Akhurst School – Proposed Residential Redevelopment

Status: PRELIMINARY
 Project: AKHURST SCHOOL REDEVELOPMENT
 Drawing: SITE LAYOUT AS PROPOSED
 Job No: 4618 Dwg No: 160:01 Rev: 01
 Scale: 1:200 At: A3 Drawn: NS Check: MD Date: 05.07.05

PROPOSAL: CONVERSION AND EXTENSION OF SCHOOL BUILDINGS TO RESIDENTIAL DWELLINGS AND ALTERATIONS TO THE EXTERNAL LAYOUT OF THE SITE

LOCATION: AKHURST SCHOOL, THE GROVE, JESMOND

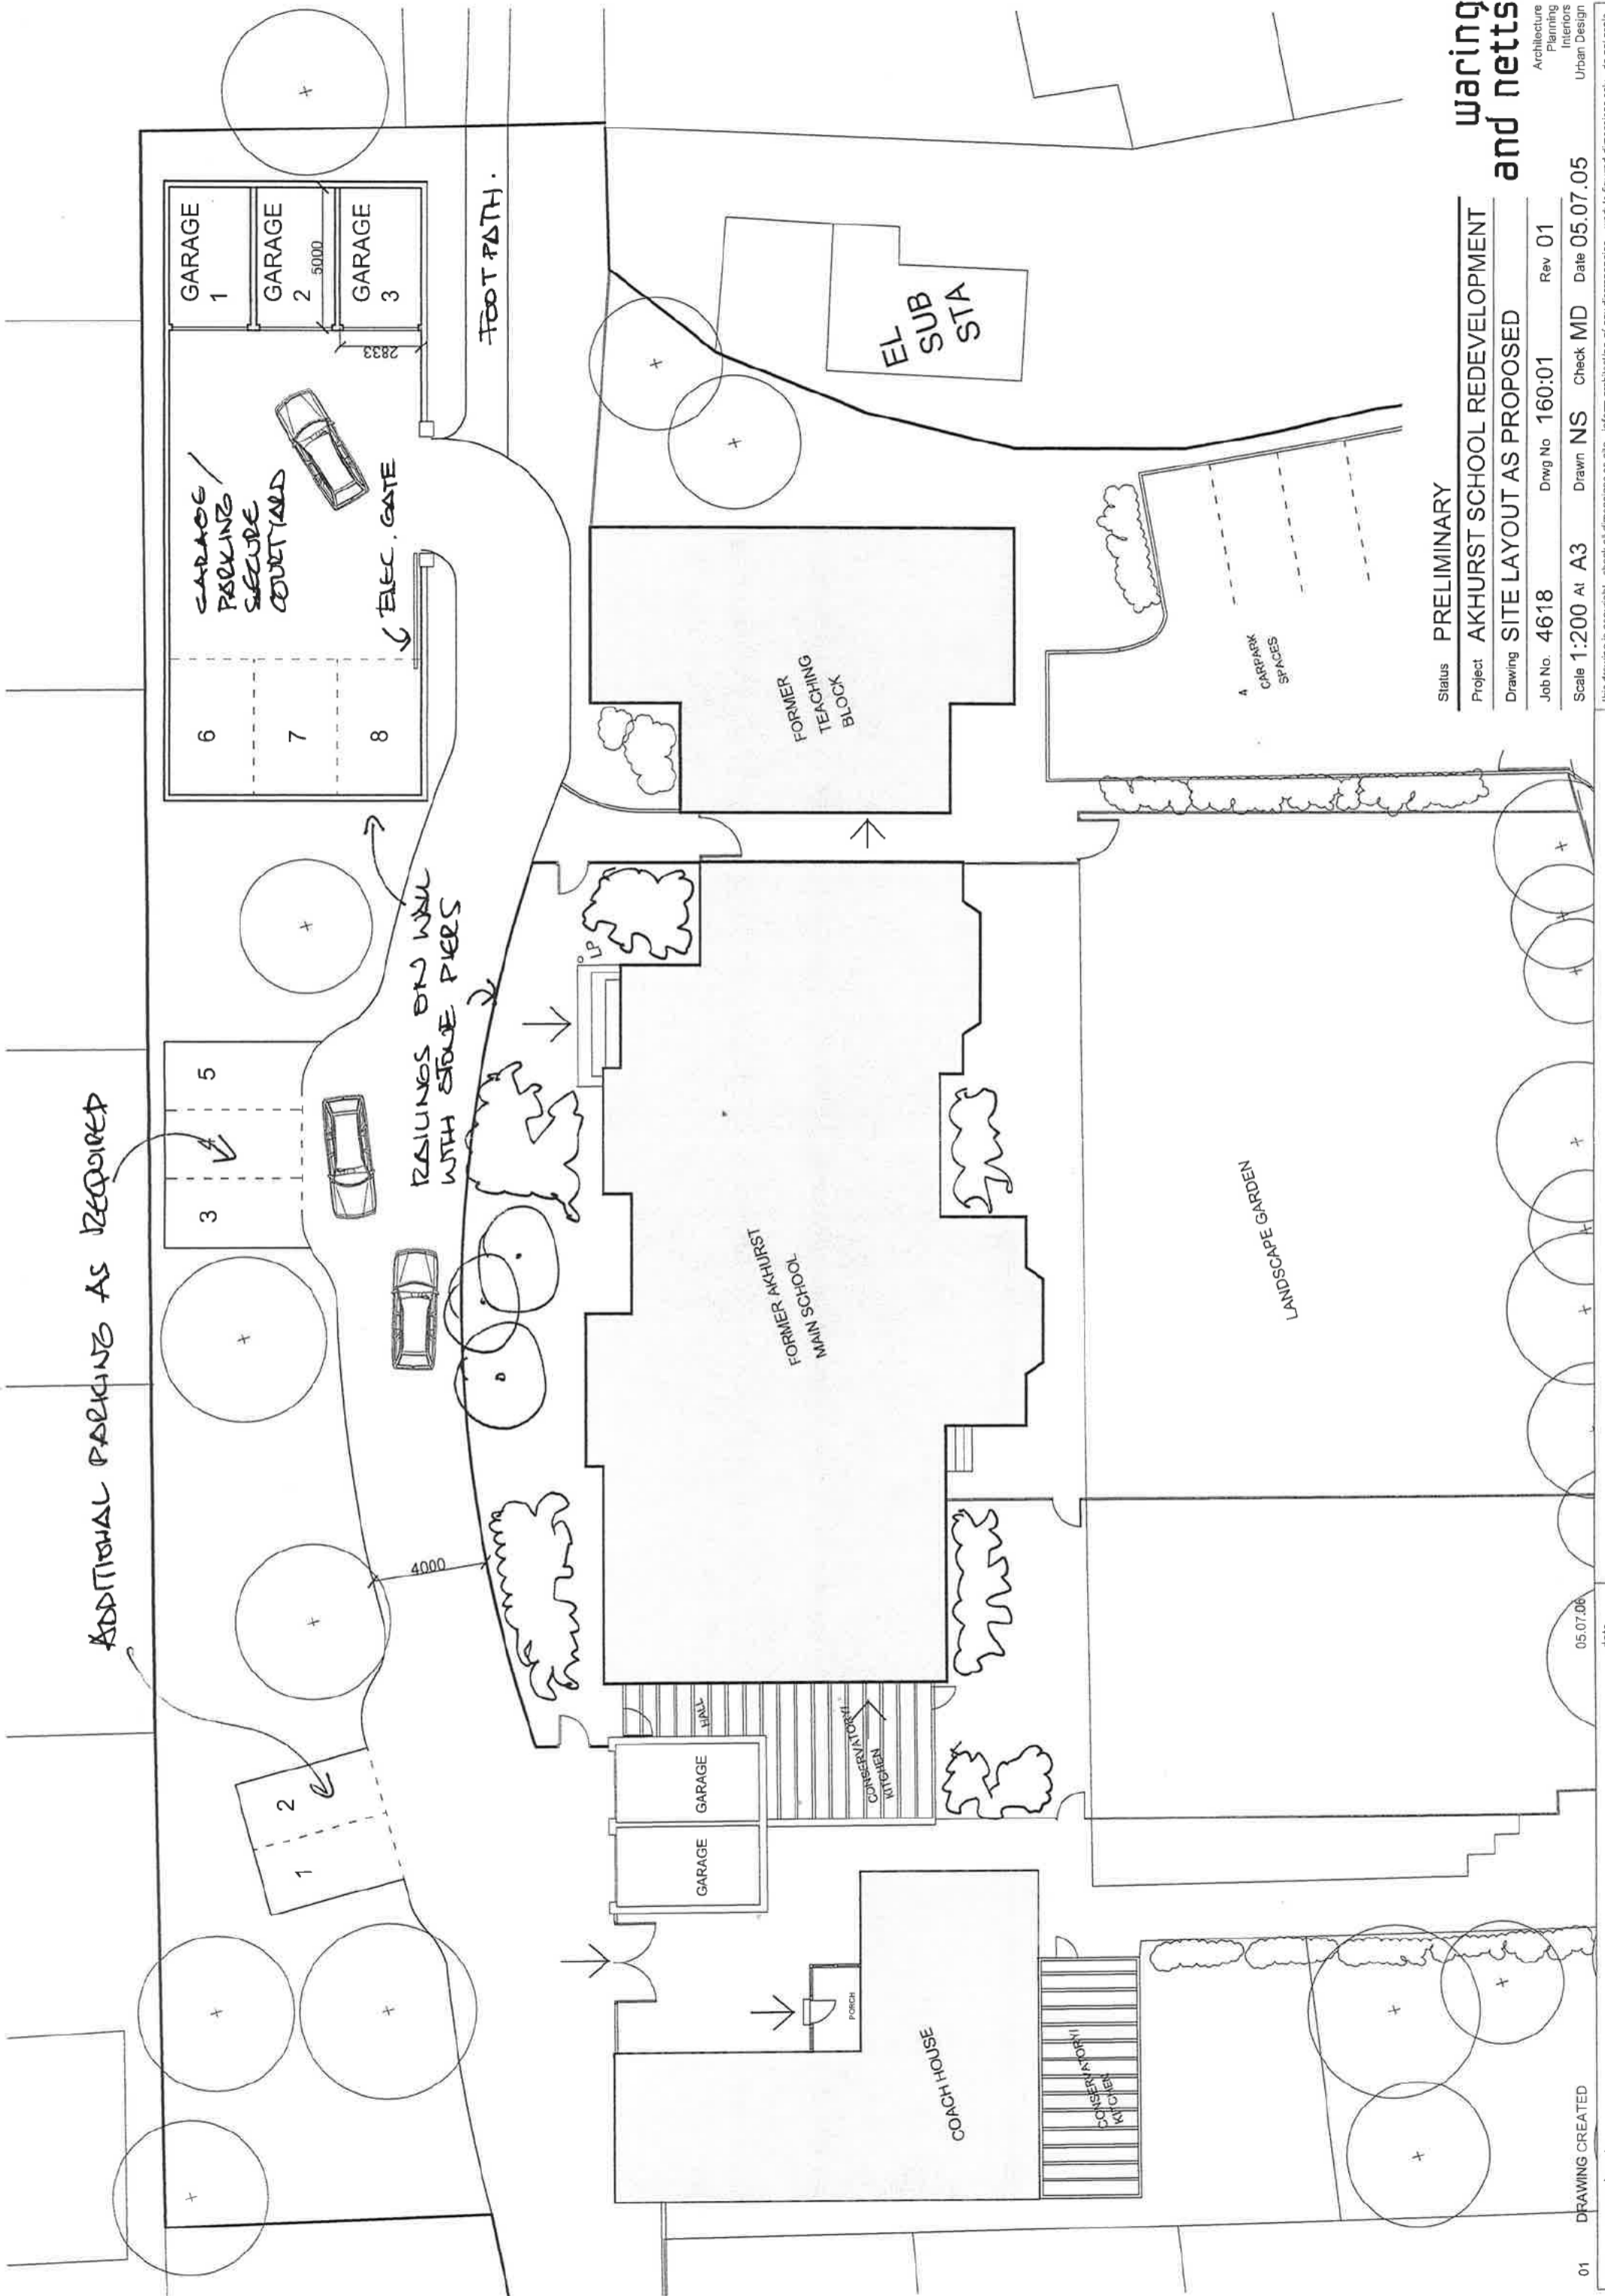
As you are aware, the most significant issue with the scheme is the proposed diversion of the existing footpath. Two proposals have been put forward and I will comment on each of them.

The first and original proposal submitted shows the diversion of the footpath around the perimeter of the site, adjacent to the boundary with properties on Reid Park Road and Reid Park Court. It is proposed to separate the footpath from the rear of the properties by enclosing the site with railings, so that the footpath is outwith the site. Three car parking spaces, three car ports and two garages would be provided within the curtilage of the residential site. The footpath would be located around the back of this space, amongst the existing trees and along the external boundary.

The proposed diversion on the first scheme would significantly alter the quality and function of the route. The existing direct line of sight along the footpath would be lost as a result of the proposed changes. The footpath would be narrowed and would be routed between the trees, with the existing close boarded fence on one side, and railings on the other. The quality of the environment on this new footpath would be significantly poorer than the existing situation. The clear line of sight would be lost which would increase the perceived and actual threat to personal safety. It is considered that this first proposal would have a significant adverse impact upon the historic route of the footpath and is therefore considered to be unacceptable. As a result of the impact upon the established footpath route, it is considered that the proposed development would be harmful to the character of this part of the conservation area. This proposal is therefore unacceptable.

As stated previously, the trees are protected and any proposal must take into account the existing trees with a presumption against any felling or works within the rooting zones of the trees. The proposed diversion of the footpath would impact upon the rooting zone of the mature trees in this area, which is unacceptable.

It is proposed to provide 8 car parking spaces for the 3 units contained within the coach house and the main school building. This represents an overprovision of parking, conflicting with Planning Policy Guidance Note 13 'Transport'. The City Councils parking standards contained within the UDP require 1 car parking space per dwelling and 1 per every 3 dwellings for visitors. Only 4 spaces in total are therefore required for the coach house and the main school building. The level of car parking proposed is not justified and should be reduced. In addition, I am concerned about the impact of the car port structure on the trees, the visual appearance of the site, and the residential amenity of the neighbours. A tree survey is required in order to fully assess the impact upon the trees but I am concerned that the structure is likely to impact upon the trees as existing.

It is also considered that the proposal would have an adverse impact upon the existing residential amenity enjoyed by the occupants of Reid Park Road and Reid Park Court. The development would result in the footpath being moved adjacent to the boundary with these properties. The occupants of these properties would therefore experience additional noise and disturbance as a result of the footpath being located closer to their properties. It is likely that significant objection would be received from residents to this aspect of the proposal and any comments received would be taken into account when a decision is made on any application.

The second proposal submitted shows the footpath running through the site, but being changed in shape from a straight line to a curve. A secure parking courtyard is proposed, accommodating 6 parking spaces in total. An additional 5 external parking spaces are proposed adjacent to this. The proposal to retain the footpath route through the centre of the site is essential, however, it is considered that the proposed curved route is not acceptable as a direct line of sight along the route is still lost. The proposed route should be a straight line as existing and the landscaped area alongside the main building should be reduced to no more than 1-2 metres in width. In addition, the proposed high railings and trees within this landscaped area are not acceptable as they would further obstruct views along the route of the path. It is considered that any wall or railing along this boundary should be low in height to ensure that the existing open character of the site is retained.

The amount of car parking on this proposal has been increased to 13 spaces for the 3 properties. It appears from the plan that these parking spaces are in addition to the 4 spaces accessed from Grosvenor Avenue. Again, this is overprovision of car parking and is not acceptable. The car parking off Grosvenor Avenue should be removed. The car parking shown to the rear of the site is still over provision even for all 6 units. I am also concerned about the impact that the secure courtyard area would have on the visual amenity of the area and the neighbouring properties, and the impact of all of the parking upon the trees. Some car parking in this area may be acceptable, subject to the trees, but it should not be formally enclosed by any walls, railings and gates. As stated previously, a tree survey is required before the impact upon the trees can be assessed.

In summary, I would recommend the following changes to the external layout plan:

- make the route of the footpath straight with a direct line of sight;
- narrow the landscaped area adjacent to the building, including removing the trees and lowering the wall or railings;
- remove the access and car parking off Grosvenor Avenue;
- provide all car parking off The Grove;
- reduce the total number of car parking spaces to 8 to meet the UDP standards;
- remove the secure courtyard area and replace with 2 small garages for the 2 properties in the main building; and
- provide adequate secure cycle and refuse storage for each property.
